UNITED STATES PATENT AND TRADEMARK OFFICE

APPLICATION NO.	FILING DATE	FIRST NAMED INVENTOR	ATTORNEY DOCKET NO.	CONFIRMATION NO.
10/532,277	04/21/2005	Andrea Drollinger	14150	8515
Orum & Roth 53 West Jackson Blvd Chicago, IL 60604-3606			EXAMINER KAVANAUGH, JOHN T	
			ART UNIT 3728	PAPER NUMBER
			MAIL DATE 01/29/2008	DELIVERY MODE PAPER

Office Action Summary	Application No. 10/532,277	Applicant(s) DROLLINGER ET AL.	
	Examiner /Ted Kavanaugh/	Art Unit 3728

DETAILED ACTION

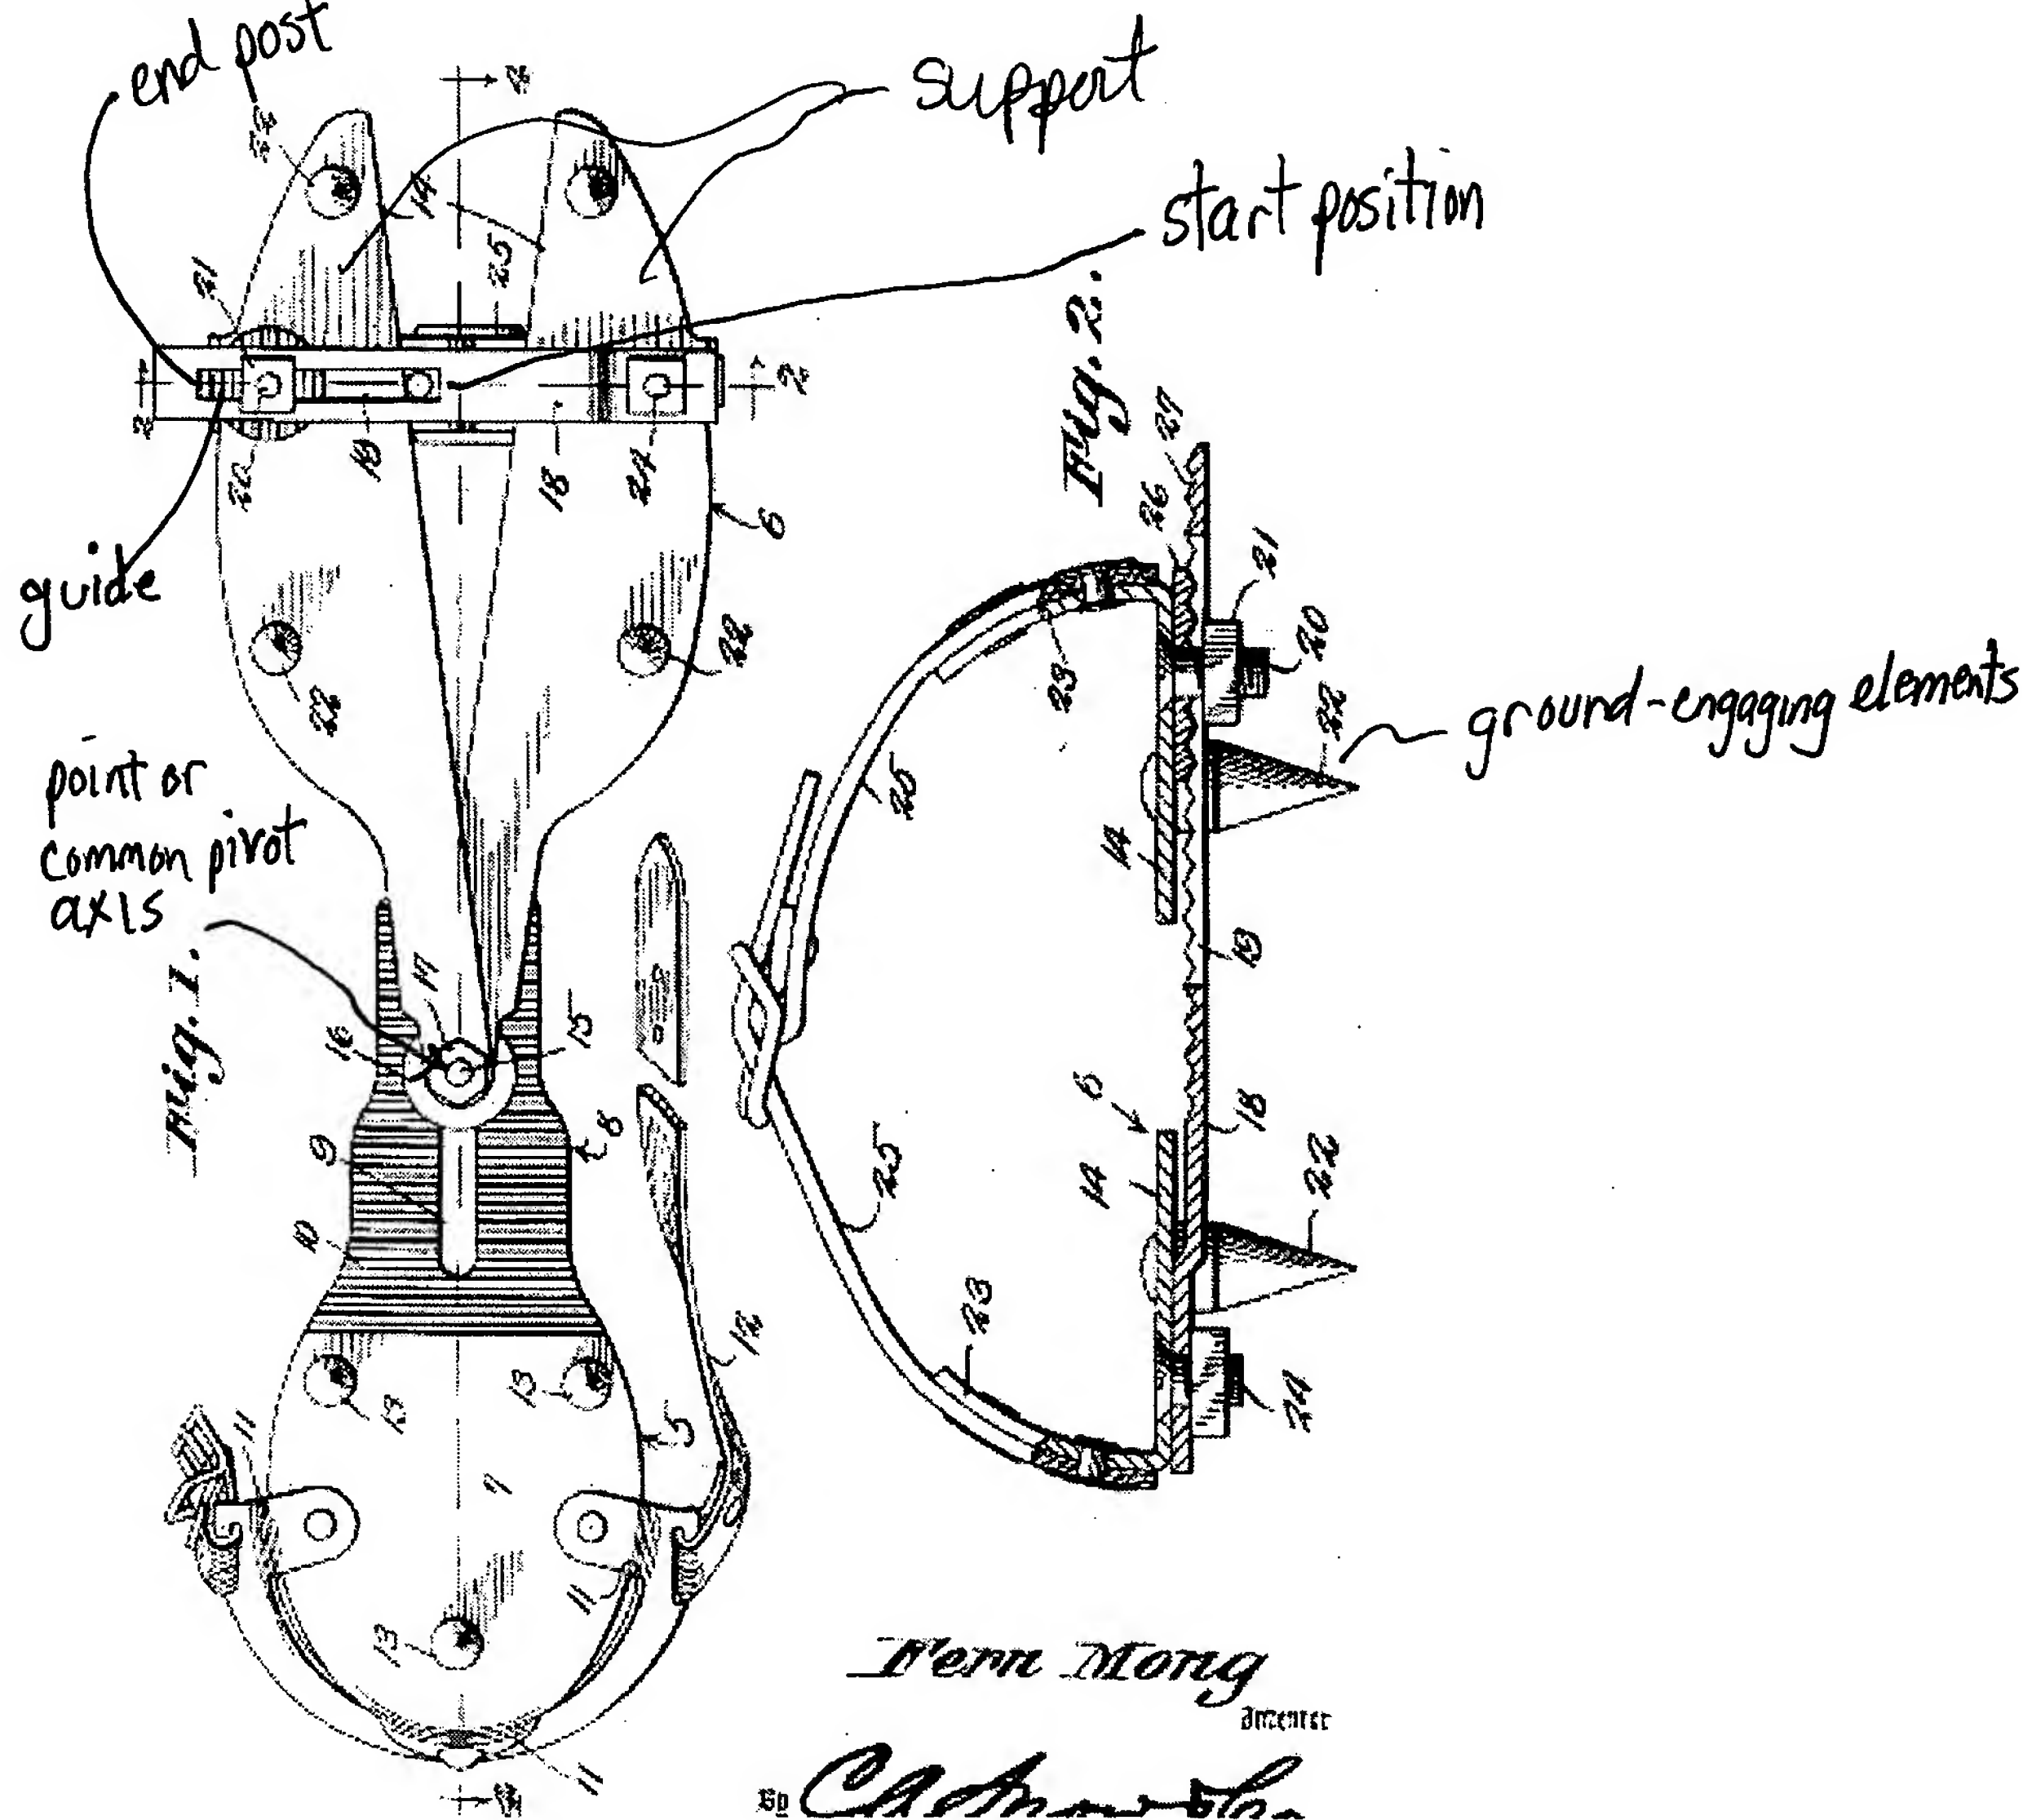
5. Claims 1-5,11,25-27,48-56 are rejected under 35 U.S.C. 102(b) as being anticipated by US 2002706 (Mong).

Mong teaches an ice creeper (sole with downwardly projecting ground elements) which is detachably mounted on a shoe, wherein the ice creeper has two support plates with ground-engaging elements which are guided and held to move forward and backward along an arc; see the marked-up figure below. The shoe can inherently be used for sports. The center of curvature is about the bolt 15 which is between the heel and the forefoot of the shoe. The mounting elements could be the bolt and nut (15,17) which are capable of being movable at all times inasmuch as anyone could thread or thread them together. Also the mounting means could be the toe section members

(14,14) which are also movable at all times when the bolts and nuts are not tightly
